Access Compliance Report

Public Rights-of-Way

Intersection ID: 10957	Main Street: CRISMAN_ST	Cross Street: PACIFIC_ST	Location:	N
ADA ID: 8423403BCBEE	Ramp Type: PerpDiag	Initial Pass/Fail: Fail	Overall Compliance: No	Severity Score: 22.5
Codes/Mitigation Info/Possible Solution		Field Measurements/Component Compliance

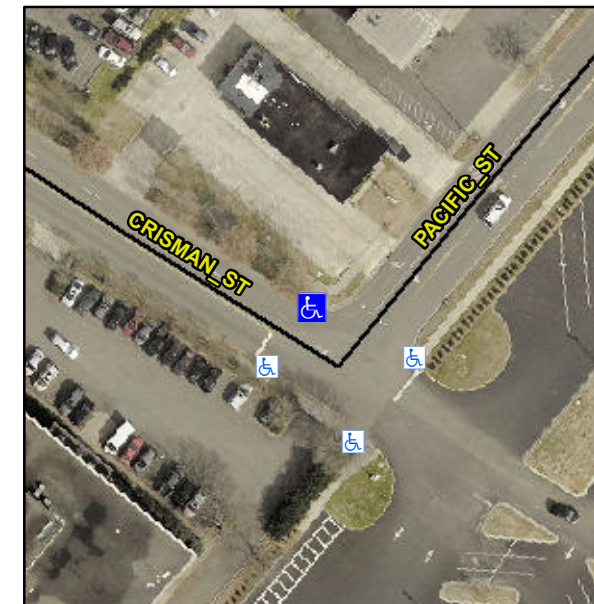
Not Found, R304.5.1, R304.2.2, R304.5.3

Compliance	Description	Data	Compliance	Description	Data
N/A	Ramp Length (in)	88.0	No	Ramp Slope (%)	8.4
No	Ramp Width (in)	45.0	No	Ramp XSlope (%)	3.7
N/A	Flare Type LT	N/A	N/A	Flare Type RT	N/A
N/A	Flare Slope LT (%)	N/A	N/A	Flare Slope RT (%)	N/A
N/A	Flare Traversable LT?	N/A	N/A	Flare Traversable RT?	N/A
N/A	Landing Length (in)	N/A	N/A	DWS Provided?	N/A
N/A	Landing Width (in)	N/A	N/A	DWS Contrast?	N/A
N/A	Landing Slope (%)	N/A	N/A	DWS Length (in)	N/A
N/A	Landing X Slope (%)	N/A	N/A	DWS Full Width?	N/A
N/A	Landing Curb? (Y/N)	N/A	N/A	DWS Offset (in)	N/A
N/A	Shared Landing?	N/A			
N/A	Gutter Ponding?	N/A	N/A	Gutter Slope (%)	N/A
N/A	Gutter Lip Ht (in)	N/A	N/A	Gutter X Slope (%)	N/A
N/A	Painted X Walk1?	No	N/A	Painted X Walk2?	No
	X Walk 1 Direction	To SW		X Walk 2 Direction	To SE
N/A	X Walk 1 Width (in)	N/A	N/A	X Walk 2 Width (in)	N/A
	X Walk 1 Slope (%)	3.6		X Walk 2 Slope (%)	1.2
	X Walk 1 X Slope (%)	2.4		X Walk 2 X Slope (%)	5.4

Remove & Replace Curb Ramp With Two New Directional Ramps or Equivalent.
